Rezoning Transportation Analysis
Petition Number: Insert Zoning Petition #2021-017
General Location Identifier: Tax ID 08904208

Revision Log:	Date	Description
	02-25-21	First Review (EL)
	03-25-21	Second Review (KP)

General Review Information

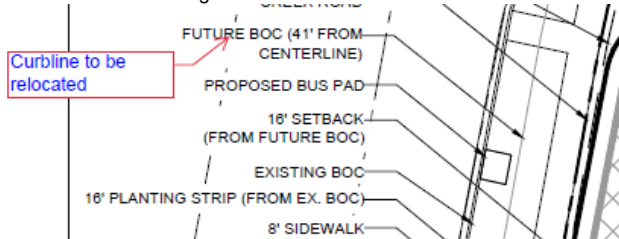
1. **Curblines:** The proposed zoning district has a setback measured from back of the existing or proposed future curblines.
 - a. **Sugar Creek Road:** Location of curb and gutter needs to be relocated to 41-foot from road centerline to back of future curb, to accommodate a future 4+ Boulevard road cross section with buffered/separated bike lanes, in accordance with Charlotte BIKES policy.

Label and dimension the curb and gutter from the centerline for each road on the site plan.

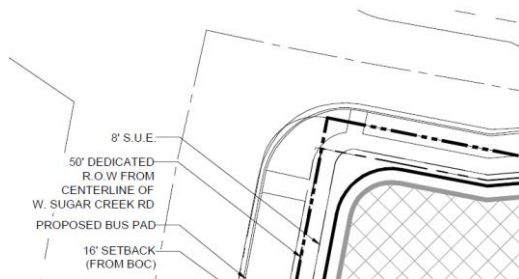
3. ~~Revise site plan and conditional note (Section 4.d.) to commit to dedicate 57 feet of right-of-way from the Sugar Creek Road centerline, to accommodate a future 4+ Boulevard road cross section with buffered/separated bike lanes. Label and dimension the right-of-way from the road centerline.~~

d. Additional Right-of-Way Along W. Sugar Creek Rd. The Petitioner will dedicate and convey fifty (50) feet of right-of-way from the existing center line of W. Sugar Creek to CDOT/NC DOT as generally depicted on the Rezoning Plan. [57]

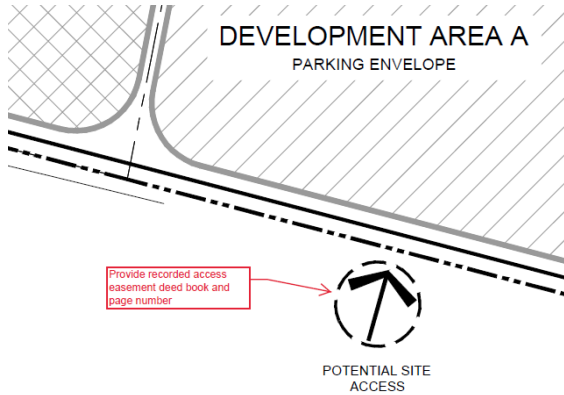
6. **Outstanding:** Site plan and conditional note(s) revisions are needed to revise conditional note (Section 4.a.) to provide a recorded access easement with the owner of PID (08904203).

Either provide a cross access easement deed book or page number with the adjacent property owner or clarify that a cross access easement will be pursued with PID 08904203

Update to Comment as a Result of the 03/16/2021 Site Plan: Revise note 4.a to read "Access to the site will be from Munsee Street and Yuma Street. Pending acquisition of a cross-access easement from Mayfield Memorial Baptist Church (PID 08904203), additional access may be provided in the form of an internal driveway connection"
